CITY OF STAR

LAND USE STAFF REPORT

FILE(S) #: FP-24-10, Final Plat, Cranefield Subdivision Phase 3

Cranefield Subdivision No. 3

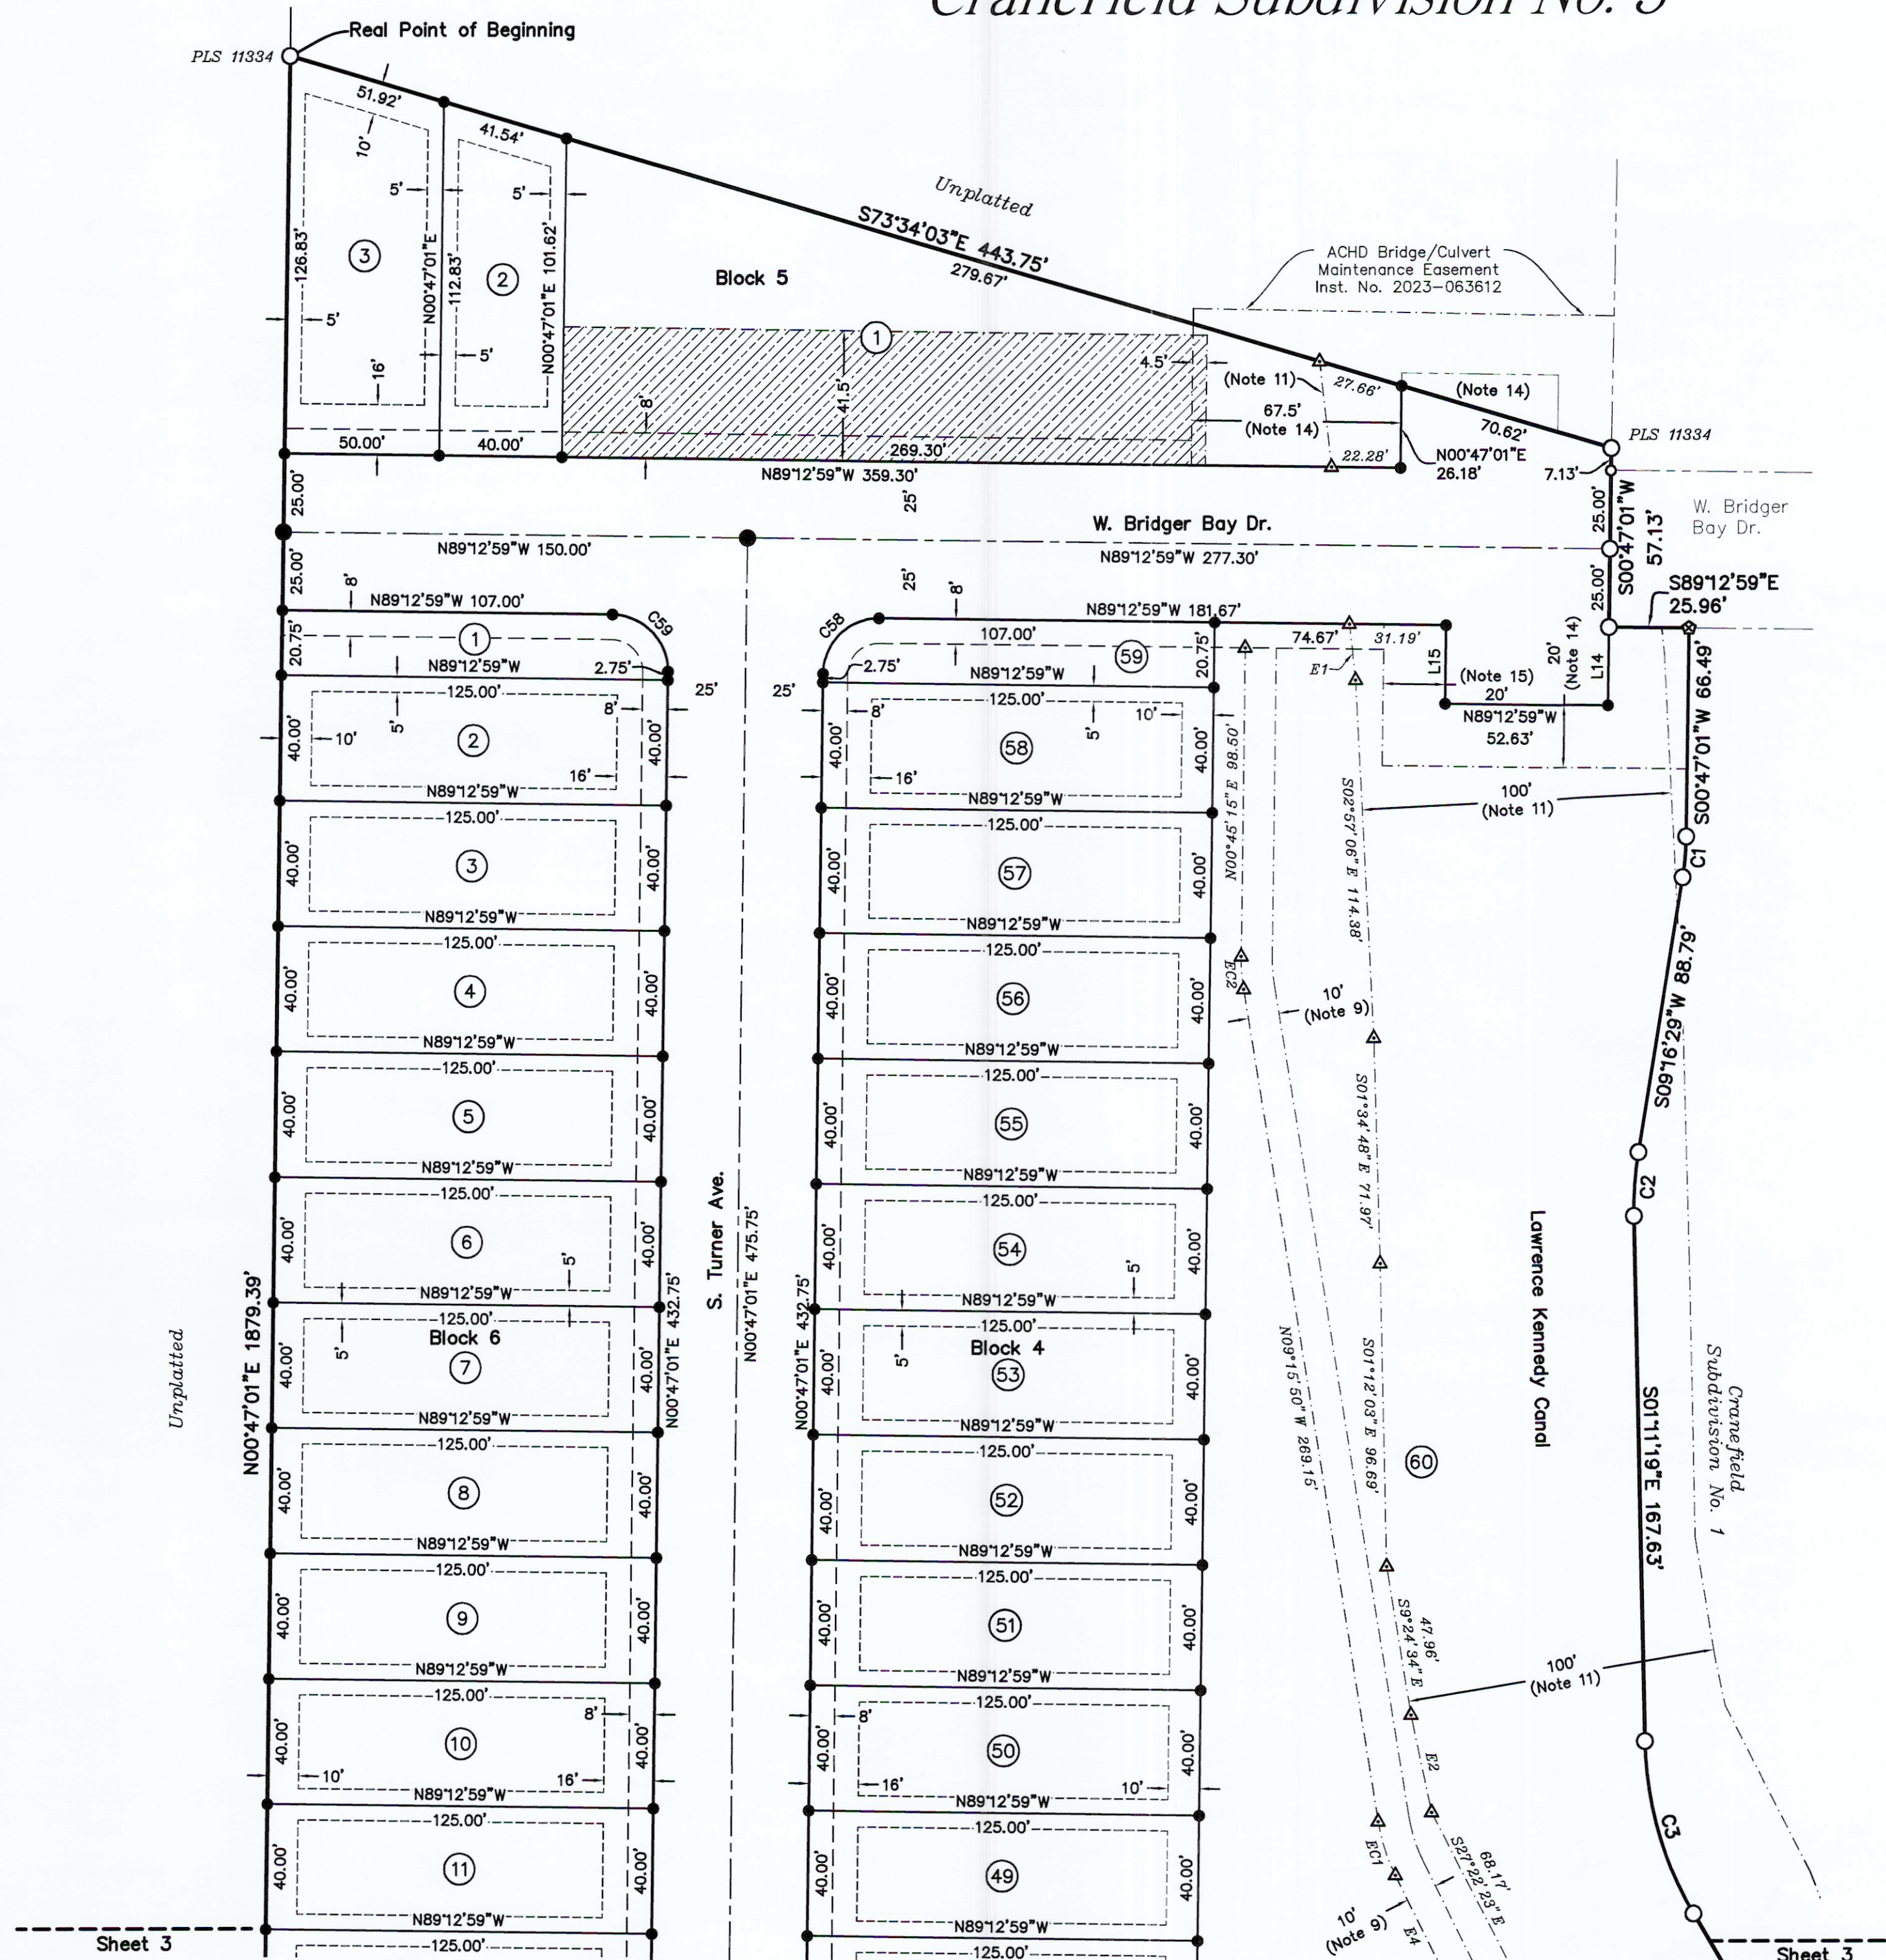
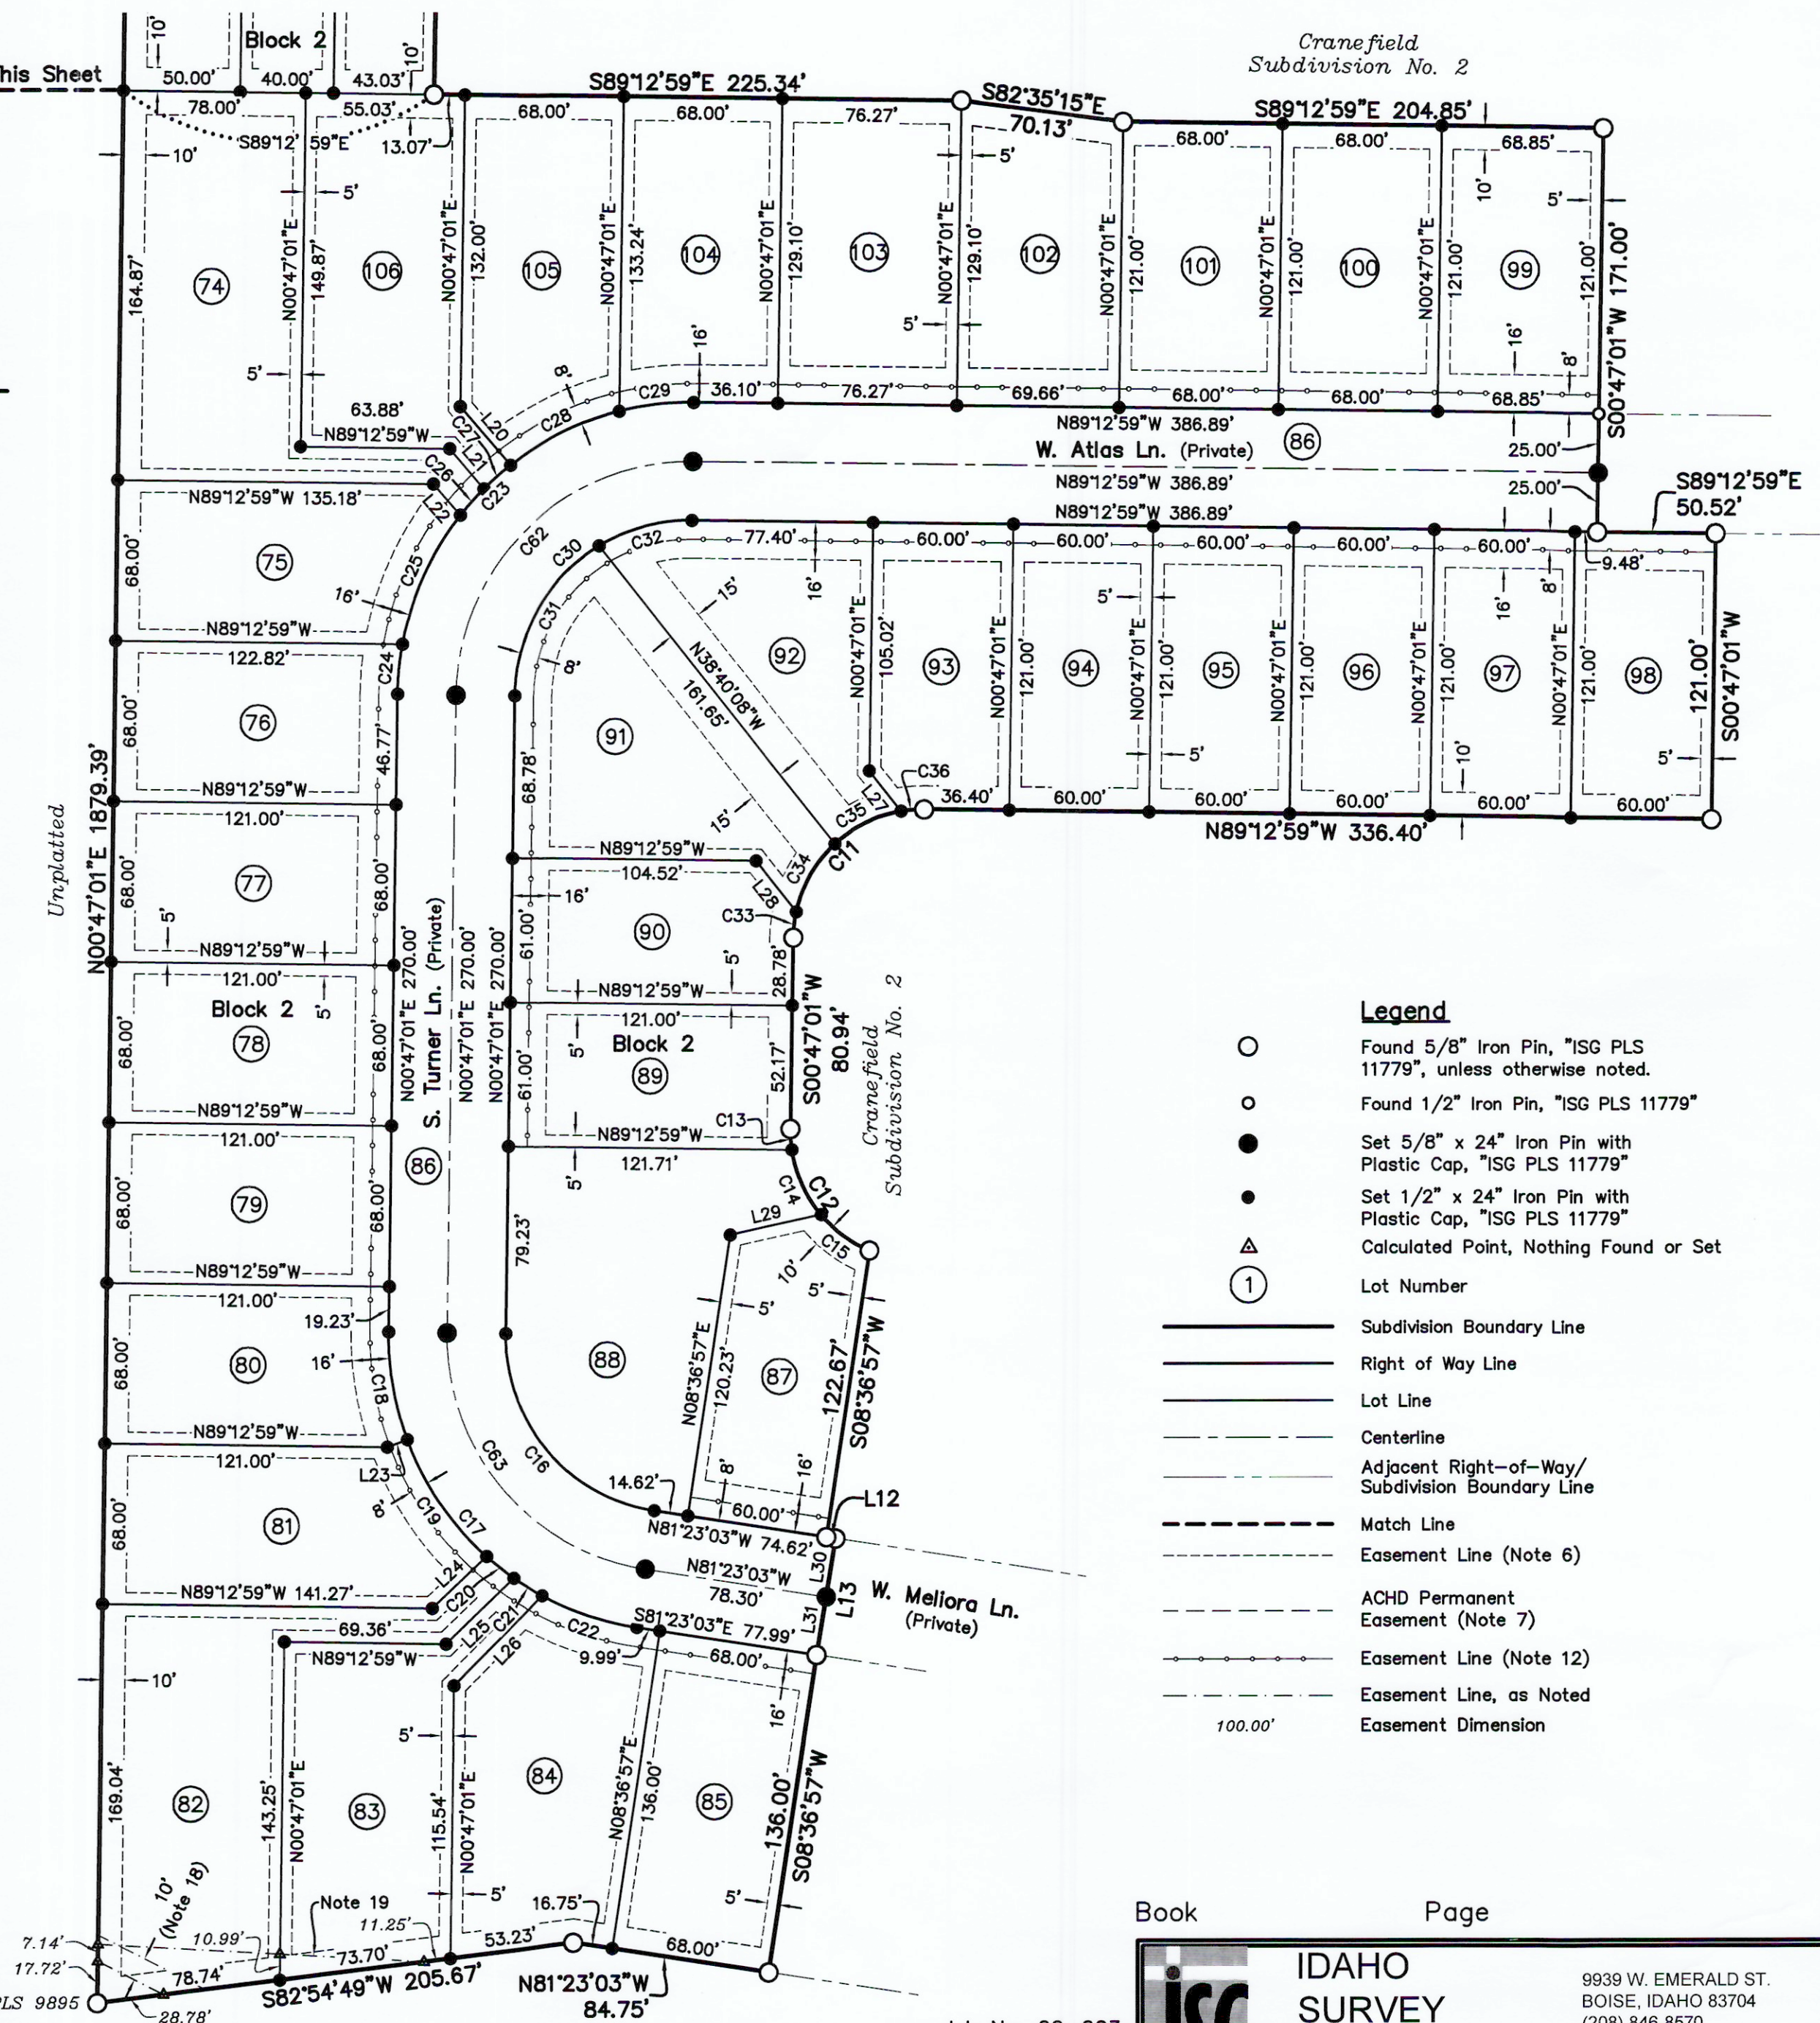
The submitted Final Plat for Phase 3 includes flag lots on Lots 74, 82, 83, and 106, Block 2. This layout does not match the approved Preliminary Plat and Star Unified Development Code, as flag lots are not permitted unless specifically approved by the Fire District. This same issue happened in Phase 2 of the development. Staff is requiring the same conditions be placed on Phase 3 per the Star Fire District requirements as outlined in the attached review letter for Phase 3. Per the letter issued by Star Fire dated October 9, 2024, the future homes on these four flag lots shall be required to install fire sprinklers in accordance with Fire District requirements. In addition, the driveways located on these flag lots shall be separated from each other using landscape strips, as common driveways are not permitted, per the UDC. This will be a condition of approval.

- 1. Prior to approval of the Final Plat by Council, the applicant shall provide Staff with a letter acknowledging the Star Fire District requirements for Lots 74, 82, 83, and 106, Block 2. This shall include the requirements for fire sprinklers in the future homes on these specific lots in addition to the landscape buffers along the private driveways of each of these lots.**
